New Bedford
5.4
SDMS 293980

DECLARATION FOR THE EXPLANATION OF
SIGNIFICANT DIFFERENCES

New Bedford Harbor Site/Hot Spot Operable Unit
New Bedford, Massachusetts

**EXPLANATION OF SIGNIFICANT DIFFERENCES
NEW BEDFORD HARBOR SITE/HOT SPOT OPERABLE UNIT
NEW BEDFORD, MASSACHUSETTS**

FIGURE 2
CONCEPTUAL CDF COVER DESIGN

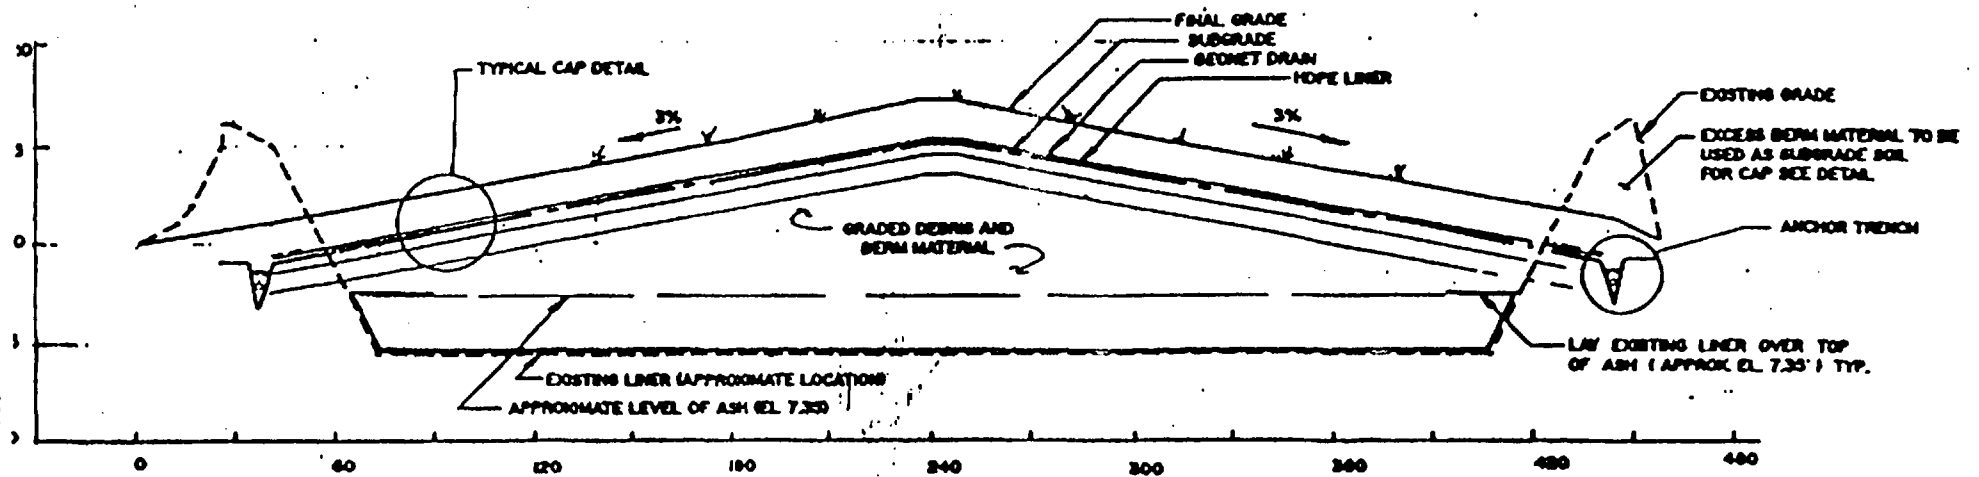
The cover for the CDF is being designed to attain the final cover closure requirements for hazardous waste landfills (310 CMR 30.633). The cover system will include a bedding layer, an impermeable flexible membrane liner (with a drainage layer) and finally, a two-foot-thick soil/vegetative cover layer. See Figures 2 and 3 for conceptual design drawings.
